APPEAL SUMMARY

Appeal ID: 21900

Project Address: 5616 NE 35th PI

Proposed use: Garage/Workshop

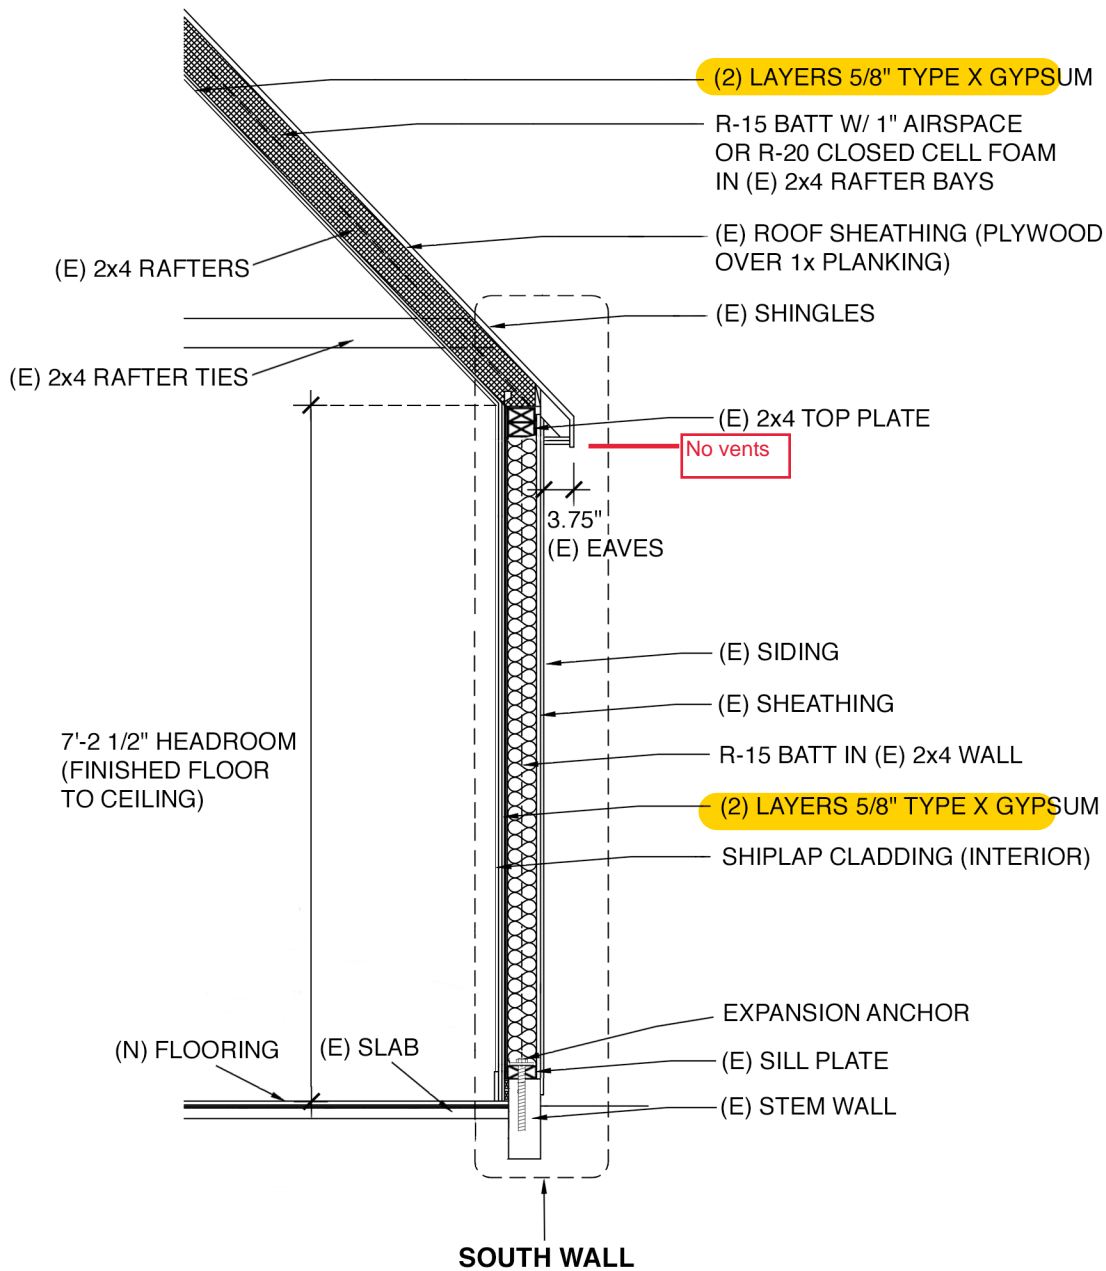
There are gaps between the existing 1x roof decking boards (which are installed between the rafters and plywood wood sheathing – see photo). Installing GWB on top of these boards and then air-sealing the assembly would create enclosed air pockets on the underside of the roof sheathing that would be prone to condensation and rot issues in the future. A similar issue exists with the 2x blocking – behind the air-sealed blocking, there would be an enclosed air cavity in the soffited eaves where moist air would be trapped and potentially create future rot issues.

WALL SECTION @ SOUTH WALL

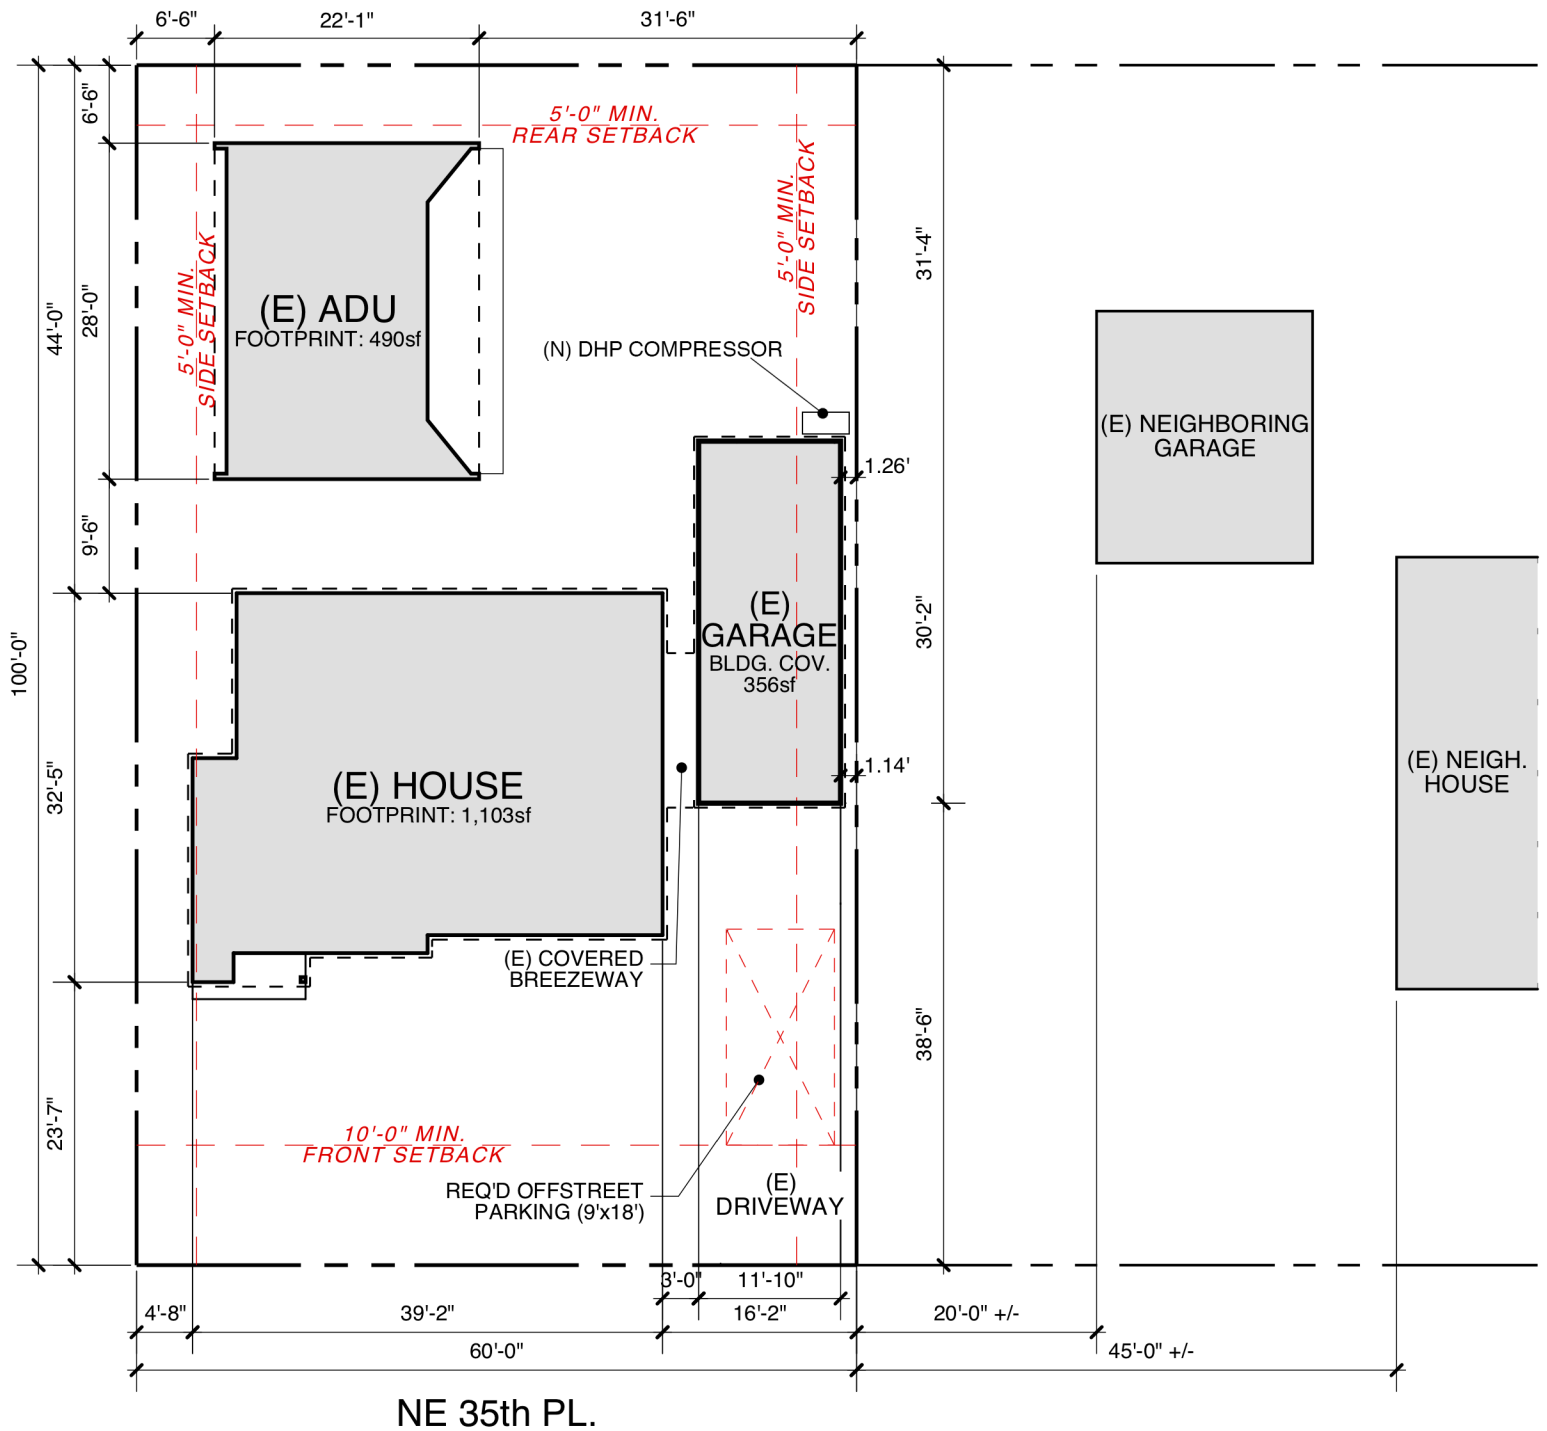
Two layers of 5/8" Type X GWB installed on entire interior ceiling of roof adjacent to property line to form continuous 1-hour fire-resistant protection with south wall assembly as approved in Appeal 21860. This design is based on based on GA File No. RC-2601 and OSSC Table 720.1(3), Item # 21-1.1.

The roof assembly would consist of the existing asphalt shingles, existing roof underlayment, existing plywood roof sheathing, existing 1x roof deck planking, existing 2x4 rafters at 24" O.C., insulation to meet ORSC code requirements (R-15 batt insulation with 1" airgap OR R-20 closed cell foam), and (2) layers 5/8" Type X GWB.

Our proposed roof assembly would combine with the approved wall assembly to form a continuous 1-hour fire-resistant barrier along the entire southern half of the garage structure. The proposed roof assembly would allow for us to sufficient insulation to meet code requirements and work for either a vented or unvented vaulted roof structure.

Alternate 1 hour wall assembly for East wall of existing garage within 3 feet of the property line: Denied. Proposal does not provide equivalent Life Safety protection. Appellant may contact John Butler (503 823-7339) with questions.
